M27 Southampton Junction **8**

Flood Compensation Areas Technical Note

Document No: HE551514-BAM-EGN-ZZ-RP-LE-0001

Figure 2 – Revised layout for NE FCA (not to scale)

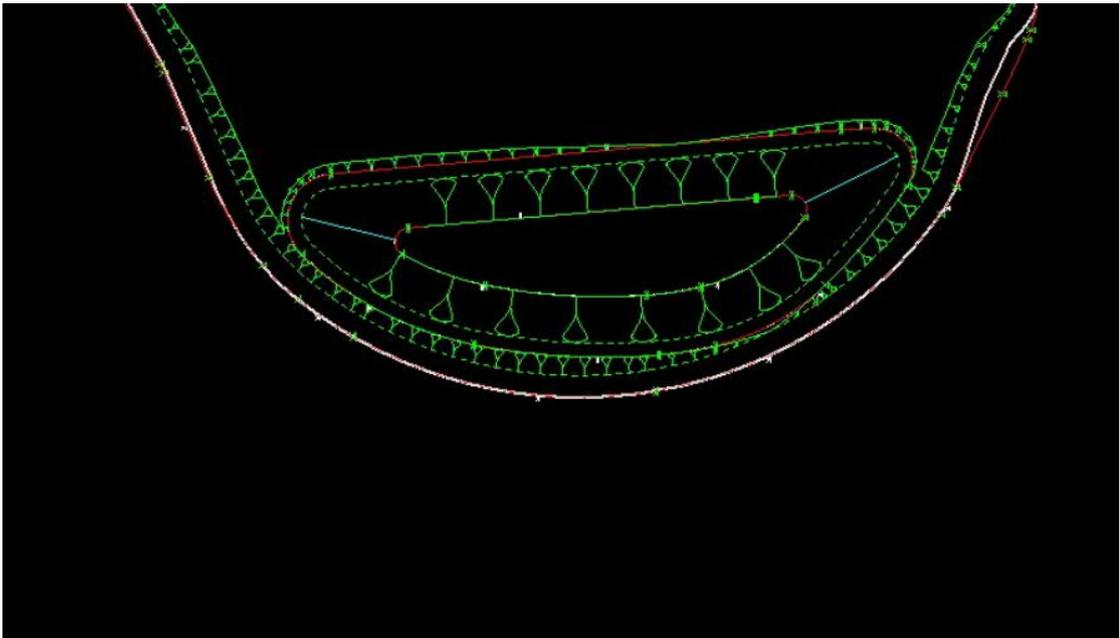
2.1.3. Figure 2 and 3 show the layouts of the revised FCAs developed by the Linkconnex design team.

Figure 3 – Revised layout for NW FCA (not to scale)

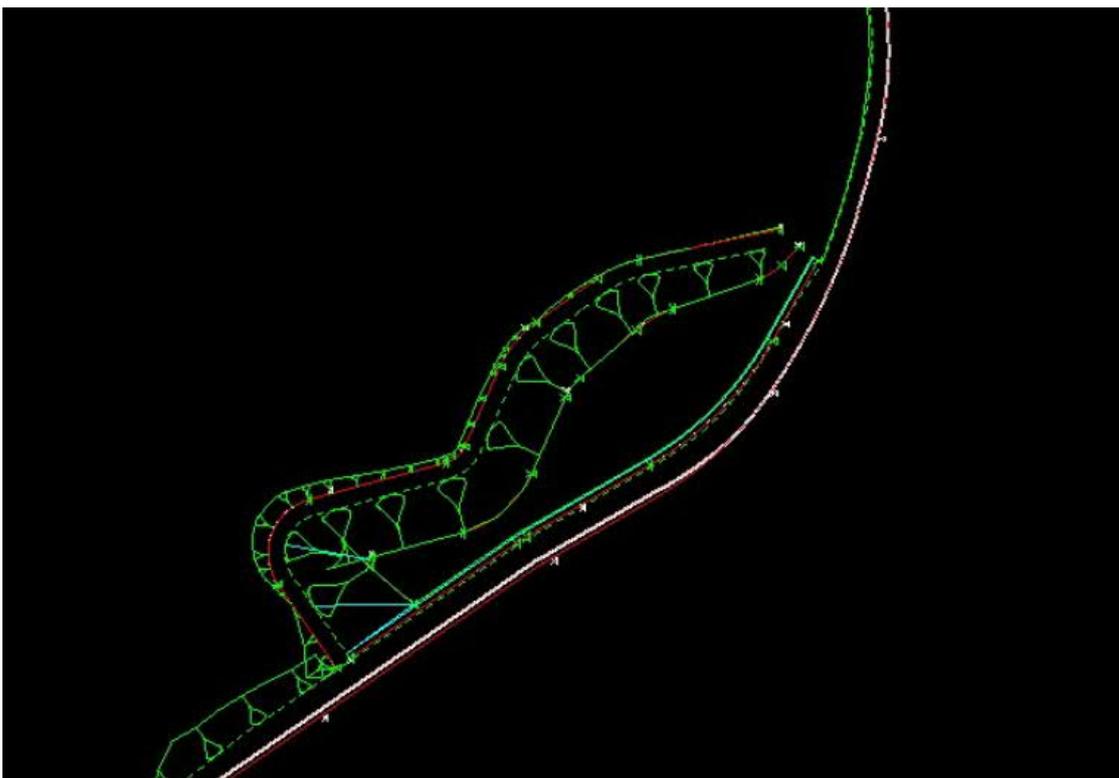
- 5.1.3. For the NW FCA, the design of the revised FCA has allowed the proposed woodland belt around the northern edge of the FCA to be retained, such that there would still be visual screening between the properties at Visual Receptor 6 and Bert Betts Way. There would therefore be no change to the landscape and visual impacts and resultant effects reported in the EAR.

Drawing Title
ENVIRONMENTAL MASTERPLAN

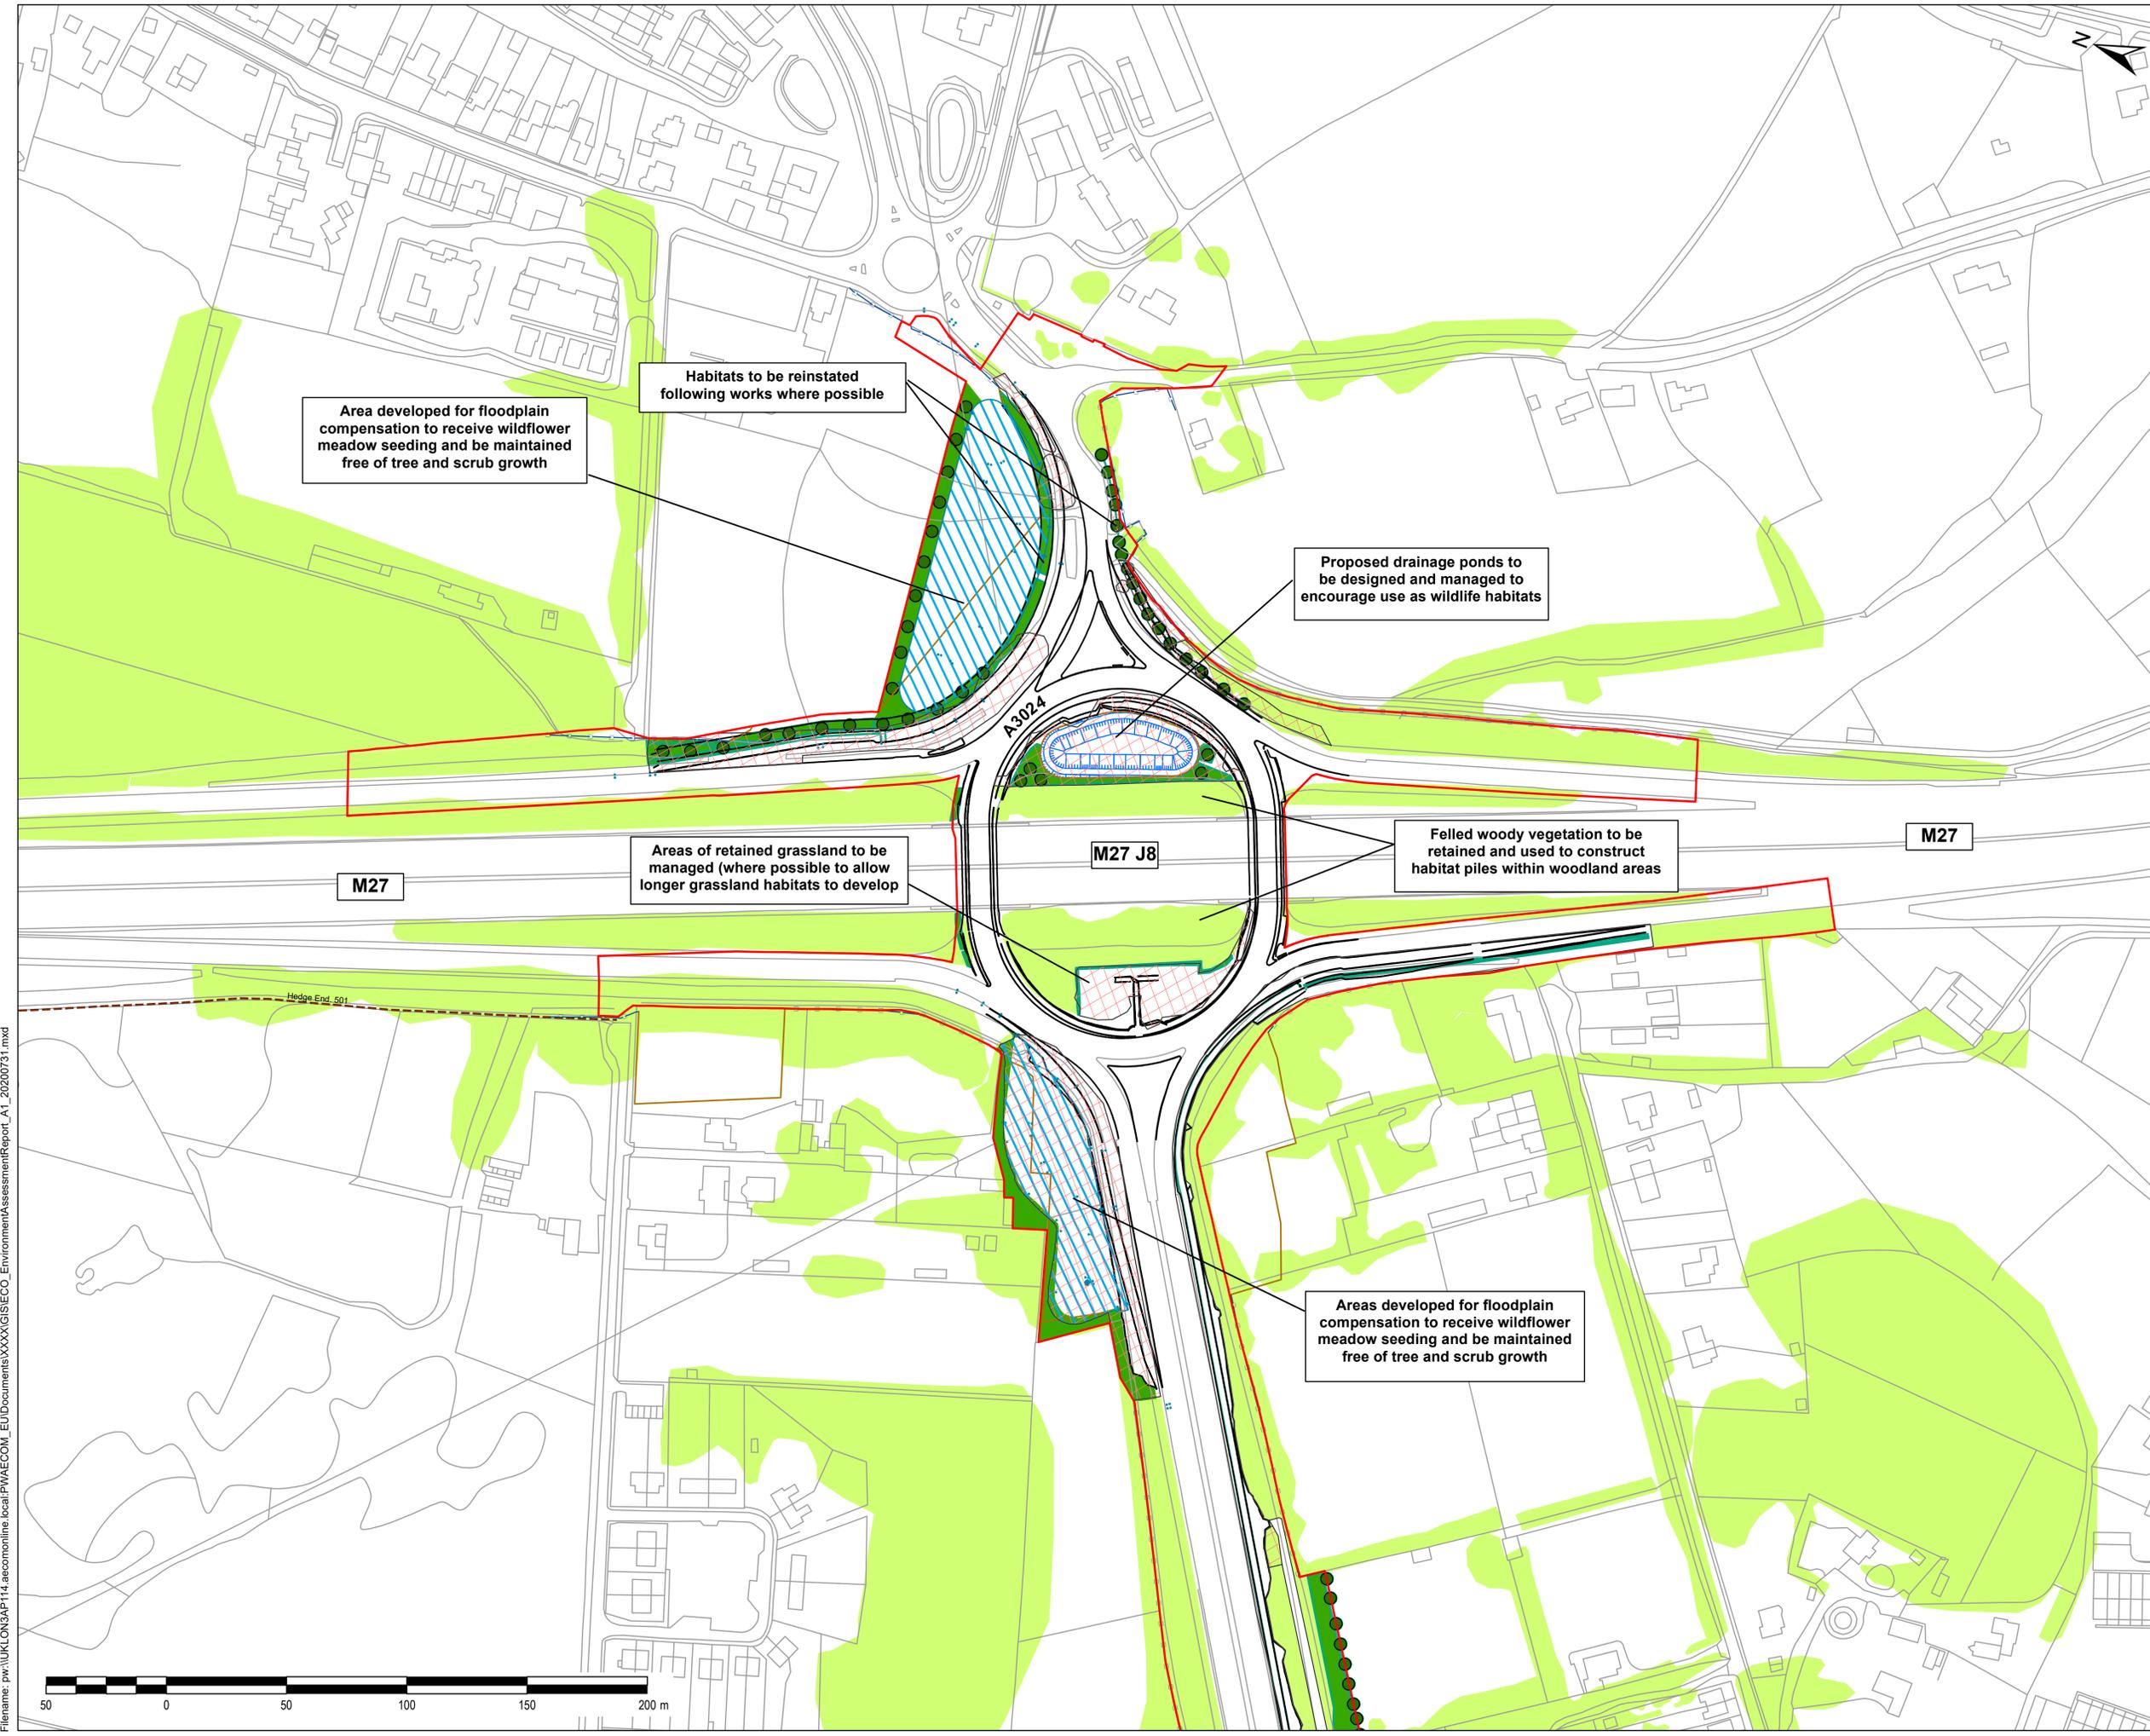
- 5.1.1. The Environmental Masterplan presented on HE551514-JAC-ELS-PCF3_SS1-DR-LE-0010 has been updated to show the footprint of the revised FCAs. Through an iterative design process, it has been possible to accommodate the revised FCAs whilst retaining the required environmental mitigation shown on the Environmental Masterplan submitted with the EAR.

- 5.1.2. For the NE FCA, the proposed woodland belt between the M27 J8 roundabout and the FCA can be retained in approximately the same position. In addition, an extra hedgerow and row of individual trees are proposed to the north of the revised FCA to better integrate it with the adjacent field, and to provide additional screening for visual receptors to the north and north east. Overall, there would be no change to the landscape and visual impacts and effects reported in the EAR as a result of the revised NE FCA layout.
